SITE PLAN
HOMESTEAD, PHASE 1
LOT 9, BLOCK F
~AMENITY CENTER~

SP2023-046: Site Plan for Amenity Center within Homestead

PROJECT NUMBER: SP2023-046
PROJECT NAME: Site Plan for Phase 1, Homestead Subdivision
SITE ADDRESS/LOCATIONS: 3200 FISHER RD, ROCKWALL, 75032

FACADE PLAN
HOMESTEAD, PHASE 1
LOT 9, BLOCK F
~AMENITY CENTER~

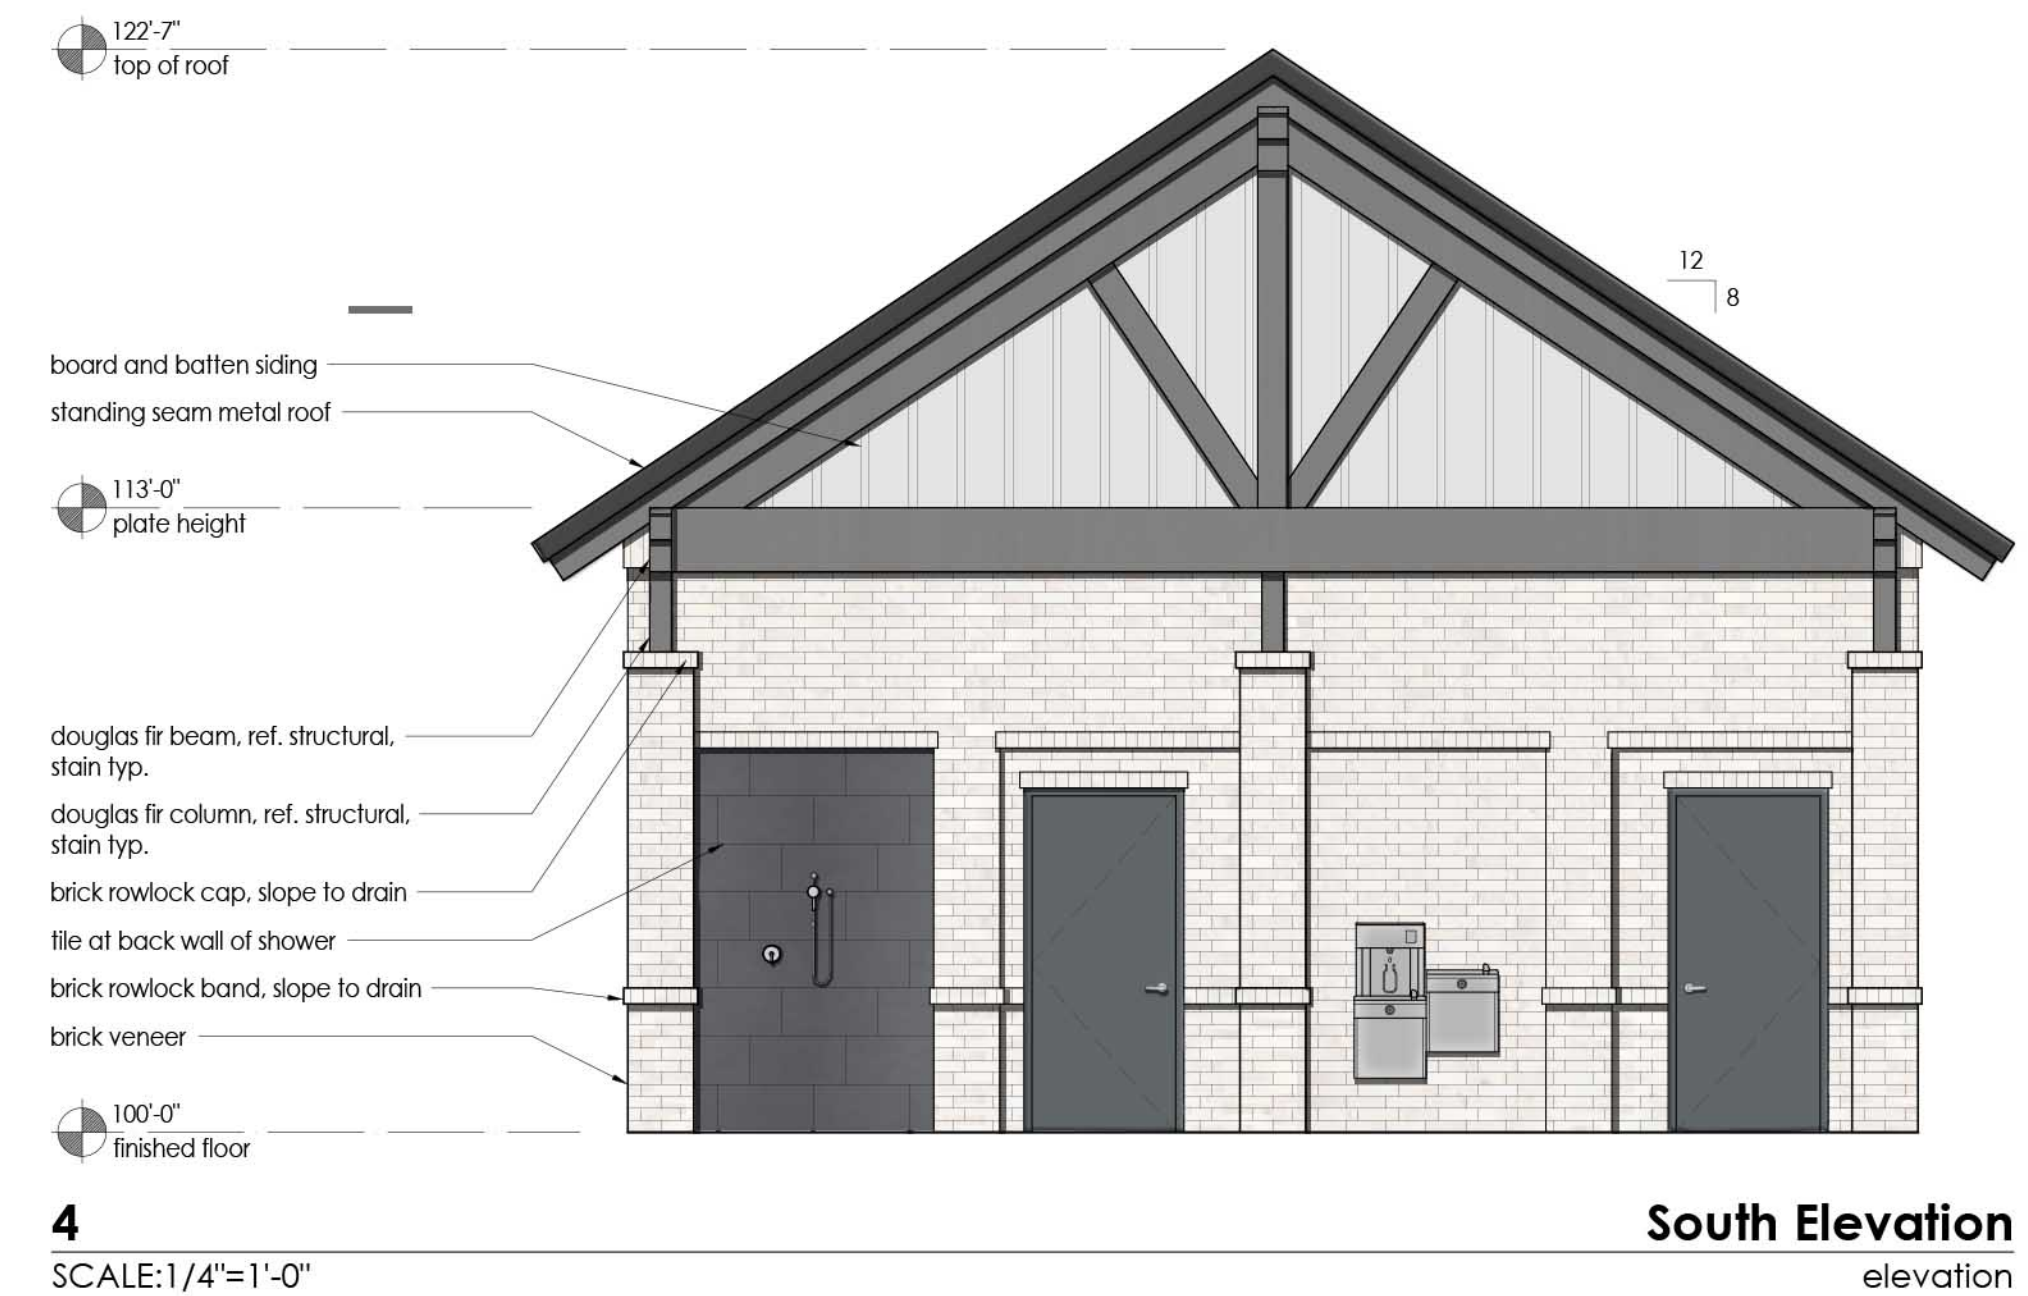
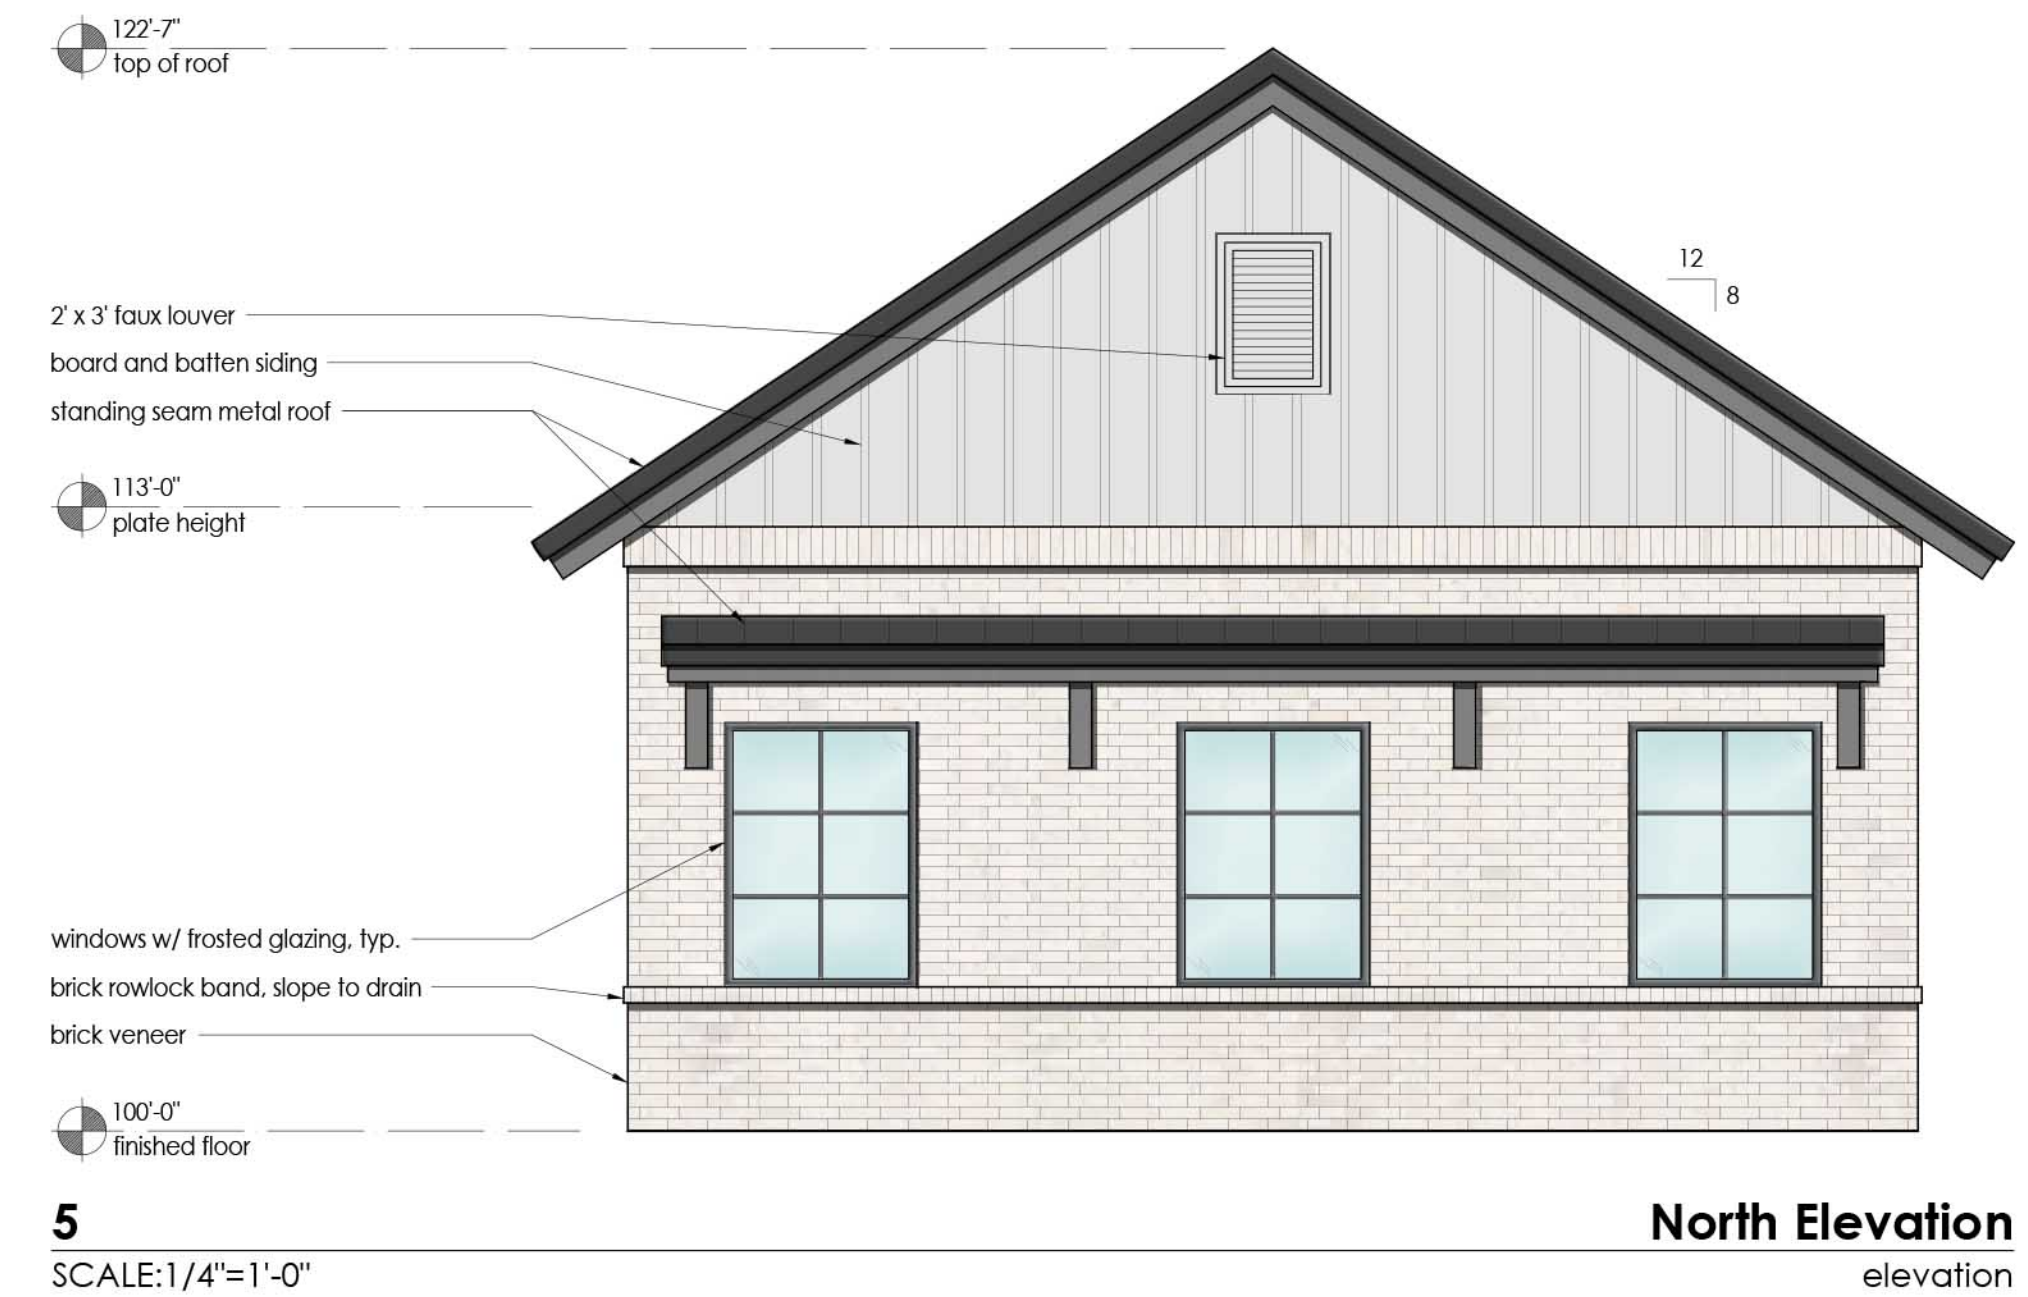
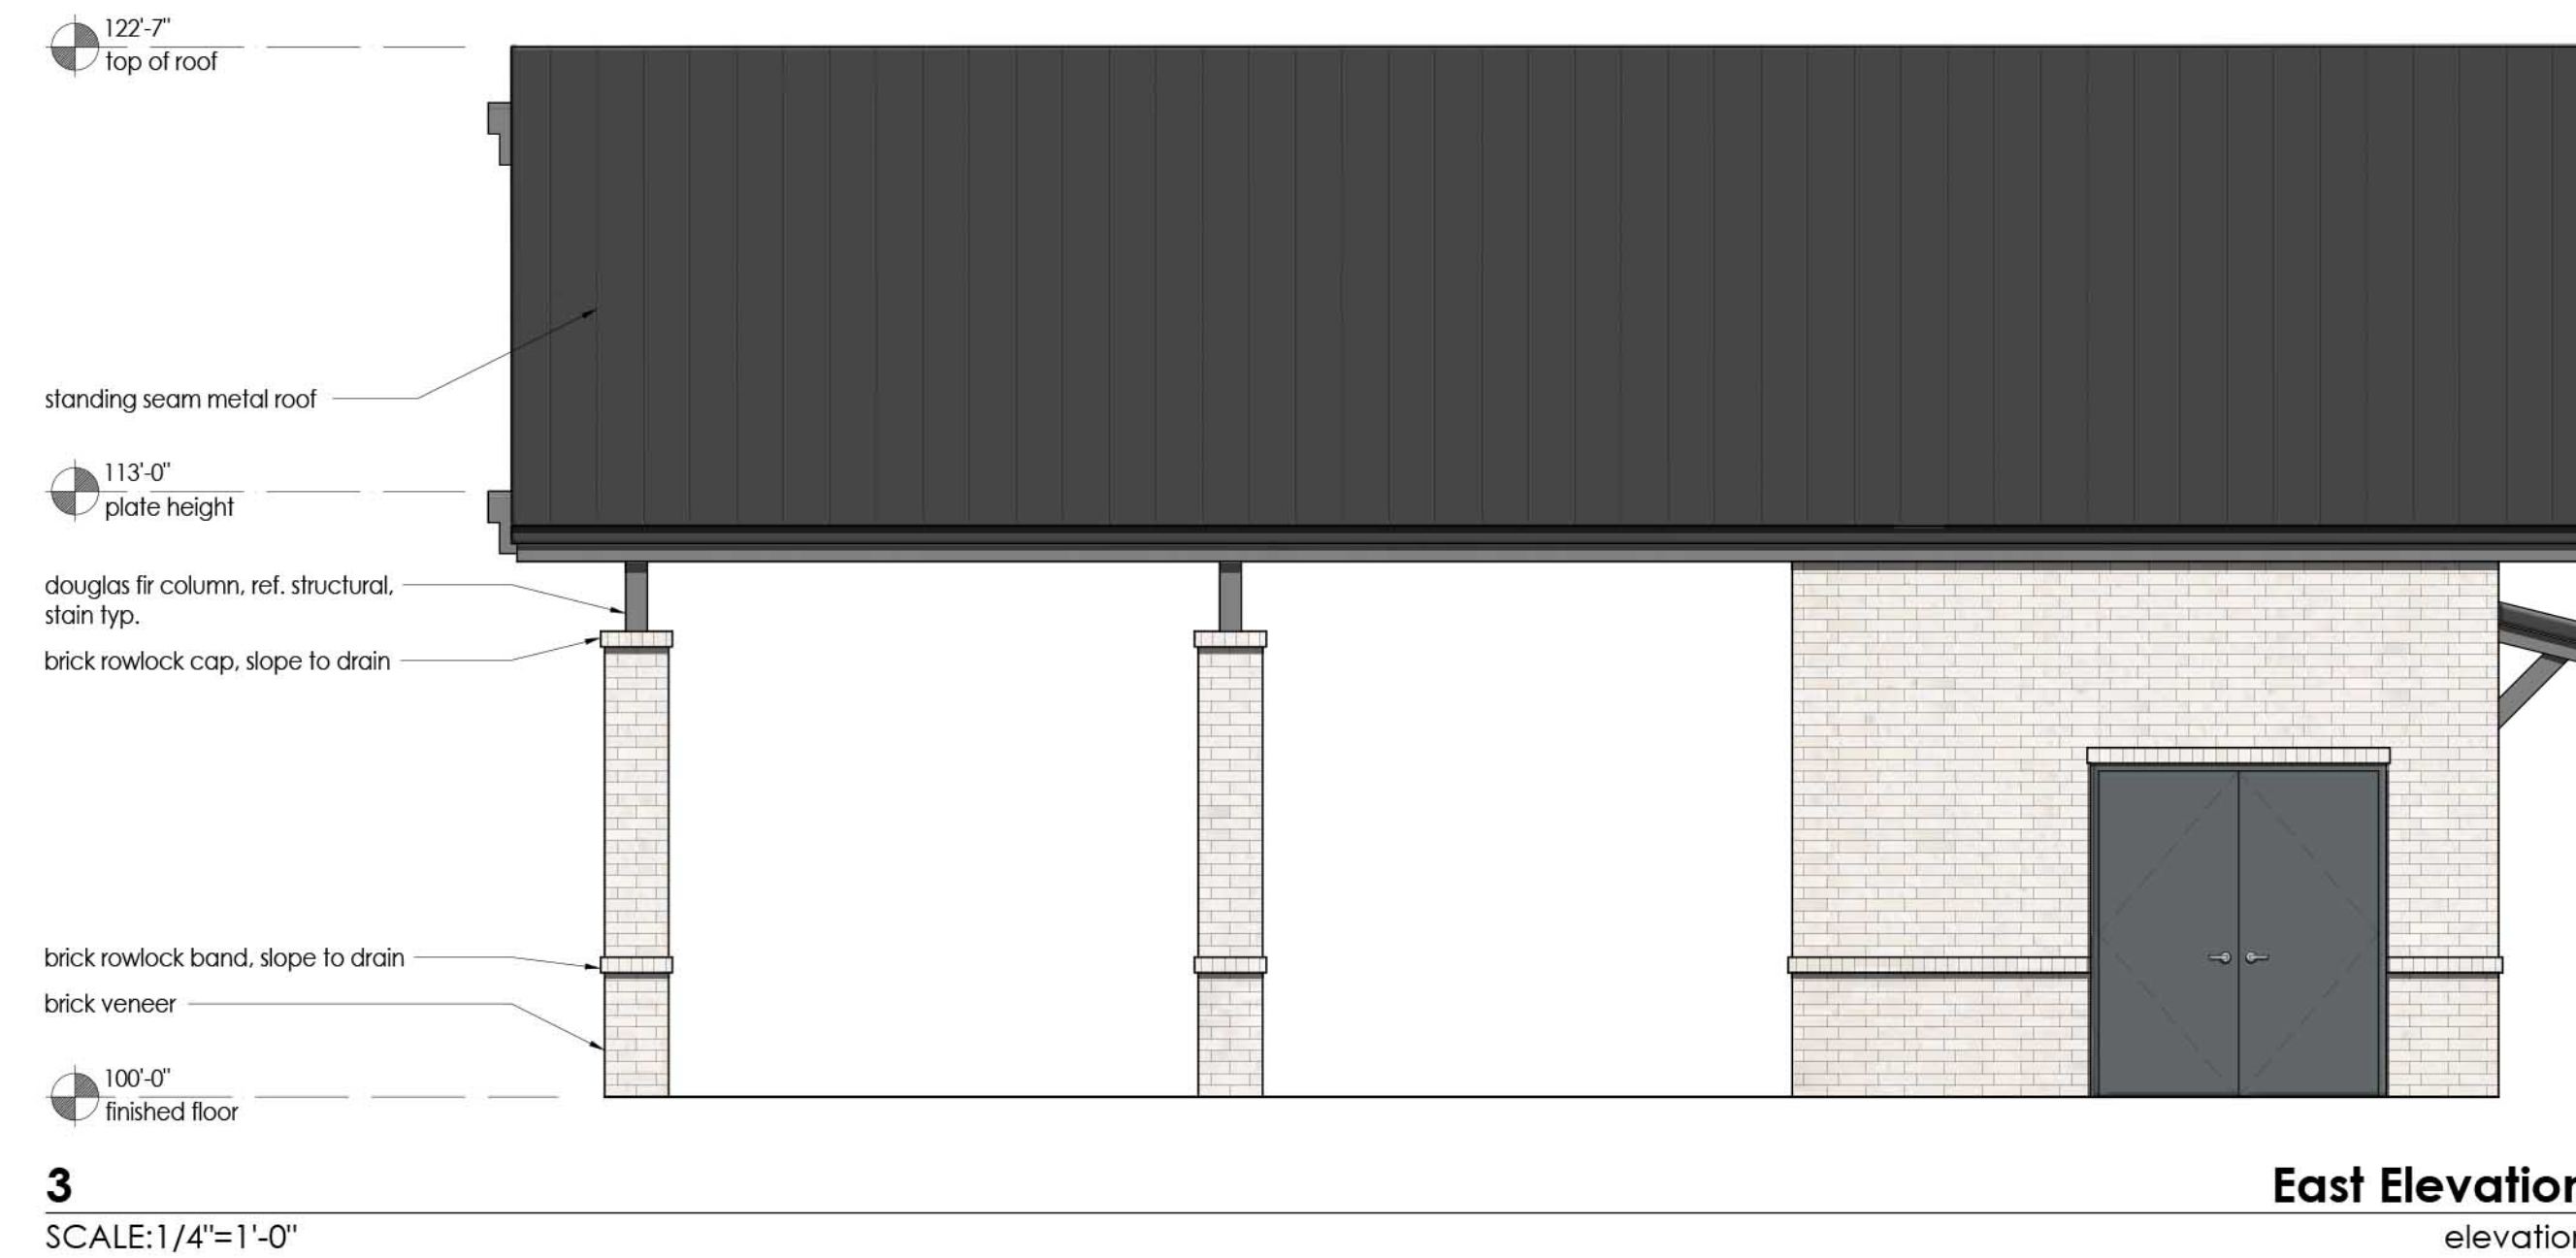
- (1) Please remove the doors and windows from the material percentages. (Subsection 05.01, of Article 05, UDC)
- (2) Cementitious material shall not exceed 50% on each façade. (Planned Development District 92)
- (3) Exterior walls shall consist of 90% masonry materials excluding doors and windows. (Planned Development District 92)
- (4) Please continue the brick up the columns. (Planned Development District 92)
- (5) The minimum roof pitch is 8:12. (Planned Development District 92)
- (6) The building elevations indicate the final materials and colors will be selected by the owner. This statement must be removed and all final materials and colors must be selected before approval. (Planned Development District 92)
